**Before the Hearings Panel
At Kapiti Coast District Council**

**Statement of evidence of James Robert Oakley on behalf Kāpiti Coast District
Council (Stormwater and Flooding)
Date: 14th August 2026**

Figure 1. Delineation of Lots and Structure Plan

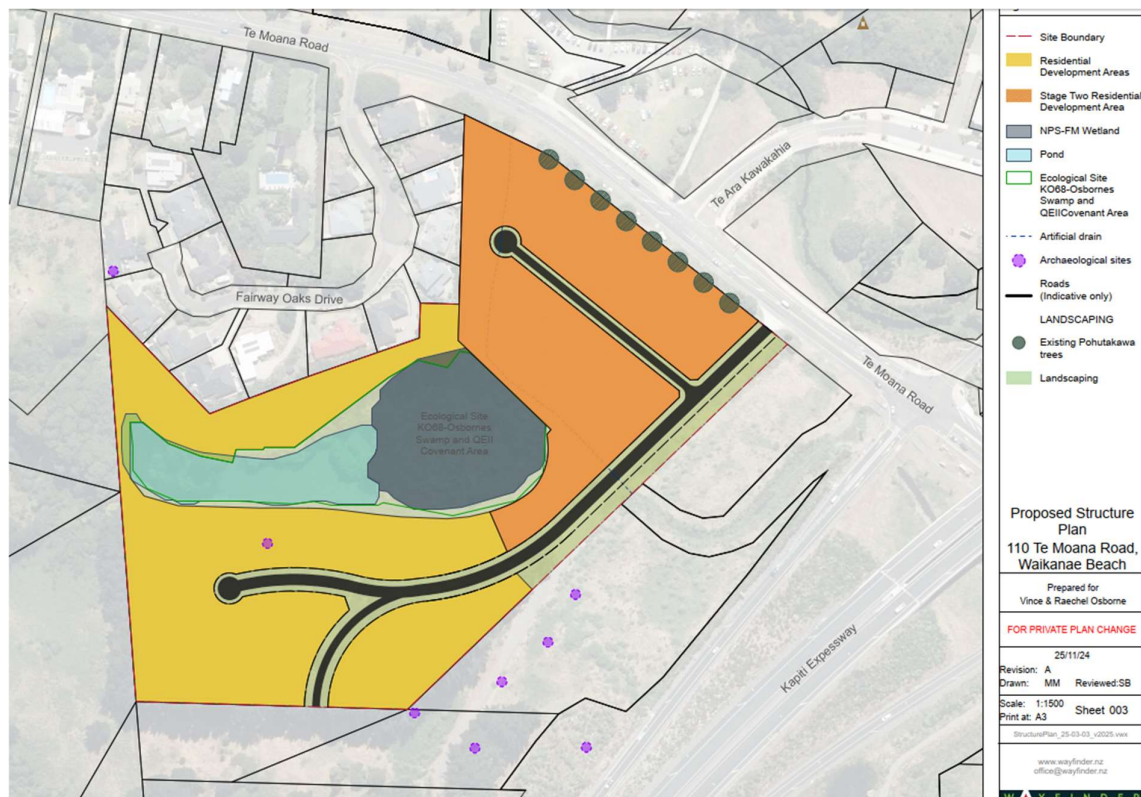
- 6.1 The existing site comprises two lots, identified as Lot 1 and Lot 2, as shown in Figure 1, which presents an extract of the scheme plan submitted with the application. Lot 1 is delineated in orange and Lot 2 in yellow. The lots exhibit different topographic characteristics and are subject to different flooding and stormwater constraints.

6.2 The topography of Lot 1 is predominantly low-lying, falling from Te Moana Road towards the adjacent QEII wetland. Lot 2 comprises a mix of elevated dune features, lower-lying land, and areas occupied by the QEII wetland. The site is located immediately downstream of the M2PP Expressway overbridge crossing of the Waimeha Stream.

Figure 2. Lot 1 and Part Lot 2 overlain Stormwater Network and Location of culverts

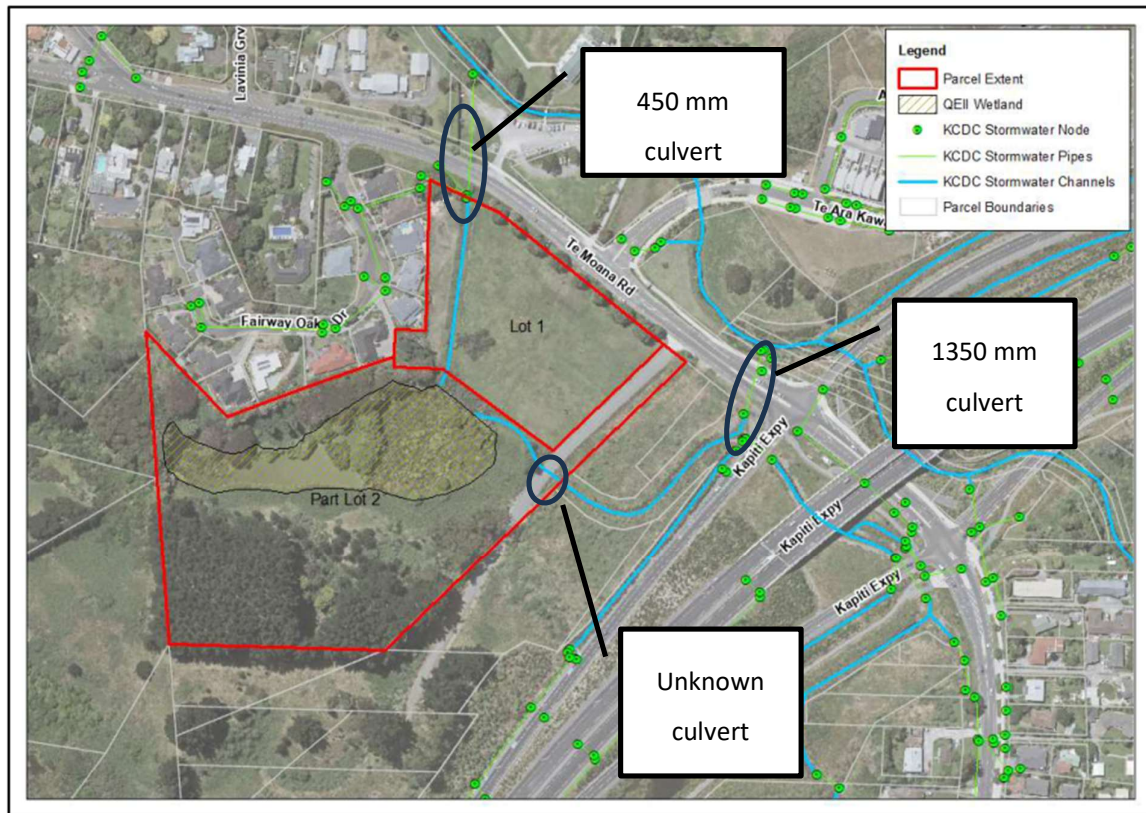
6.3 The site and associated upstream sub-catchment discharges stormwater via two culverts under Te Moana Road discharging to the Waimeha Stream. A culvert in the northwestern corner of Lot 1 and the second culvert located adjacent to Te Moana Road and the Expressway off-ramp. The KCDC Three Waters Services Map as presented in Figure 2 show these culverts as 450mm and 1350mm diameters, respectively. These culverts form a key component of the site's drainage network and influence the ability of floodwaters and stormwater runoff to discharge from the site.

- 6.4 The AWA Environmental Ltd Stormwater Management Report (SMP) for the Applicant notes these culverts are tailwater controlled during the KCDC 100-year ARI 2130 model as a result of stream flows and downstream tide levels. Consequently, the ability of the culverts to discharge runoff from the site becomes constrained during major storm events.
- 6.5 I understand from Mr David Pickett, Council's ecologist for PPC5, that the drain connecting the site and QEII wetland to the 1350mm culvert is severed, likely as a result of the construction of the accessway into the site. On that basis, I understand that the original hydraulic connection may have been altered or severed. However, the Kāpiti Coast District Council (KCDC) Three Waters Services Maps show a culvert beneath the accessway crossing, although its size and condition are not known to me.
